Re: DEQ Response to Evergreen System Review

This is in response to the DEQ's July 16, 2007 review of the Evergreen System Review ("ESR") submitted by Pall Life Sciences ("PLS") on May 10, 2007. PLS has reviewed the cover letter and the attached model review prepared by Rick Mandle. PLS offers the following general comments as well as specific responses to key DEQ conclusions.

**Pall Life Sciences**  
 Scio Twp., Washtenaw County, Michigan  
**Response to Evergreen System Review**

Figure 1

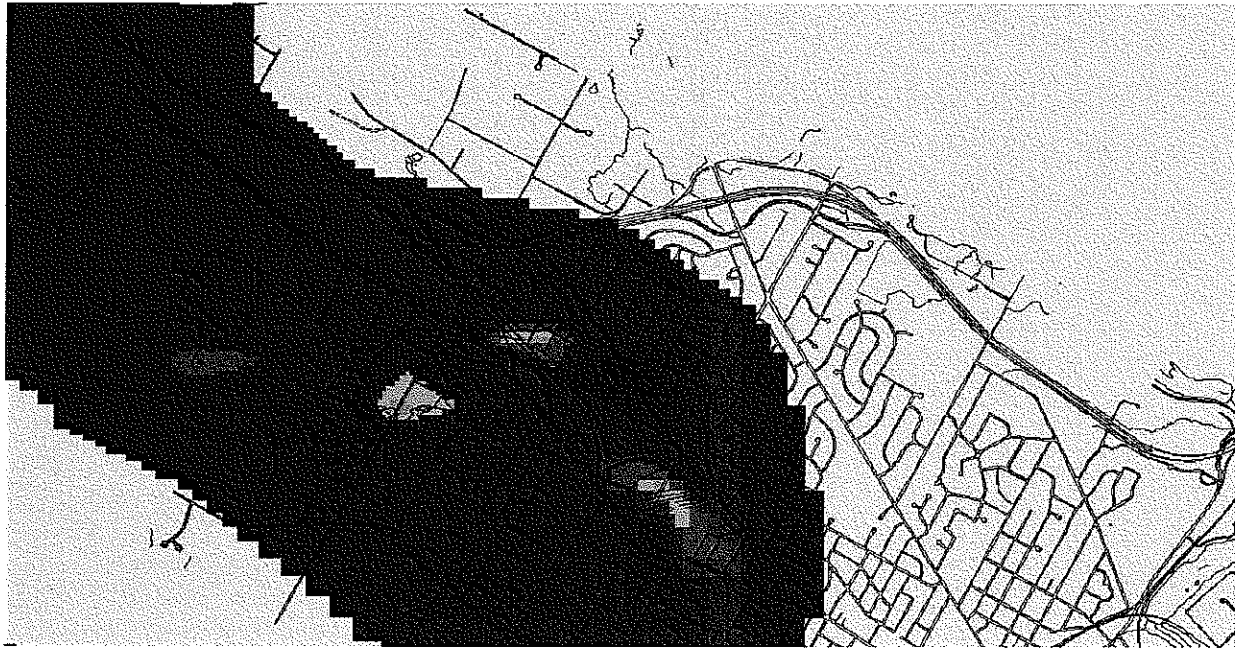
*As outlined in detail by Mr. Mandle, there are deficiencies in the construction and calibration of the model PLS relied upon for this analysis. The deficiencies include the model representation of the degree of hydraulic connection between the Unit D<sub>2</sub> and Unit E aquifer and the model boundary conditions. The PLS model assumes there is no connection between water bearing layers that represent the Unit D<sub>2</sub> and Unit E aquifers, while at the same time asserting that pumping from the Evergreen extraction wells are pulling in contaminated groundwater from the Unit E aquifer. Evidence that this assumption is not applicable include the fact that soil boring GSI-96-01, installed in the southwestern area of the Evergreen Subdivision, showed there is no confining unit that hydraulically separates the Unit D<sub>2</sub> from the Unit E aquifer in this area.*

Contrary to this statement, the model does include a connection between the Unit D<sub>2</sub> and Unit E (specifically the upper E or E<sub>1</sub>) in the areas where data suggest such a connection exists. Figure 1 is a screen print of the hydraulic conductivity of the model layer (Layer 3) that vertically separates the two aquifers. The figure shows four areas where zones of high hydraulic conductivity were assigned to simulate the connection between the two aquifers. These areas include the area around GSI-96-01, the Maple Village area, the Wagner Road area, and west of the Pall property north of Third Sister Lake.

PROJECT NO.  
 F96502B  
 FIGURE NO.  
**2**

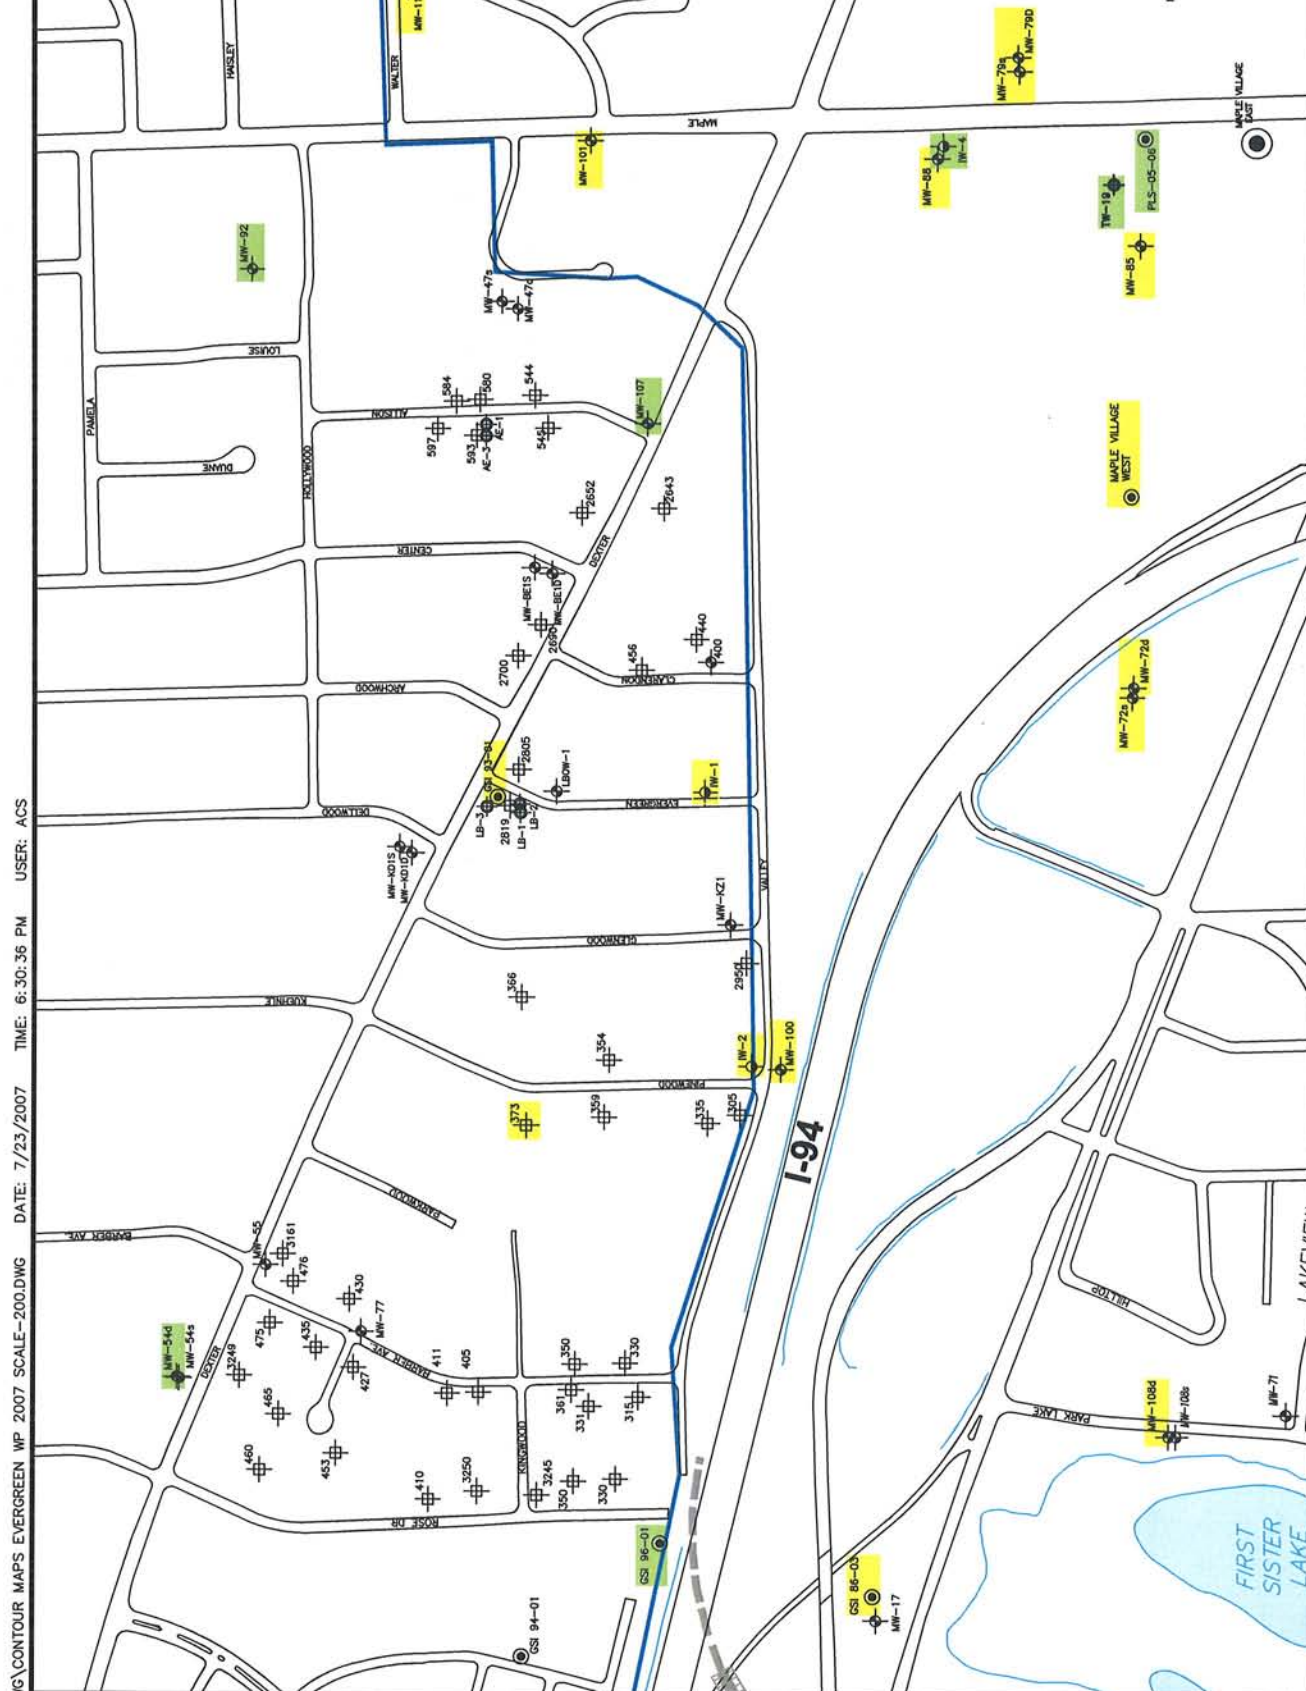
*In addition, the stratigraphy in the central and eastern areas have not been vertically profiled to depths sufficient to conclude that there is no connection between the Unit D<sub>2</sub> and Unit E aquifers in this area.*

Figure 2, (attached as Attachment 2), identifies all of the borings that were drilled to the bedrock surface in the area of the Evergreen Subdivision. Also shown are borings that were drilled to depths (over 200 feet) sufficient to encounter Unit E (E<sub>2</sub>). All of these borings were drilled with the knowledge and involvement of the DEQ. At each of these locations, significant separation was observed and documented between the Unit D<sub>2</sub> and E aquifers. Drilling data indicates that the diamicton separating these aquifers in this area is extremely stiff (often exceeding 100 blow counts/6-inches). In fact, at two locations, drillers broke auger strings drilling through it.

The DEQ has never, until now, suggested this data was not sufficient to demonstrate hydraulic separation between the Unit D<sub>2</sub> and E (E<sub>2</sub>) in the Evergreen Subdivision, nor has the DEQ requested that PLS further investigate this issue. The DEQ's response in this regard inexplicably ignores the voluminous data PLS has provided on this issue.
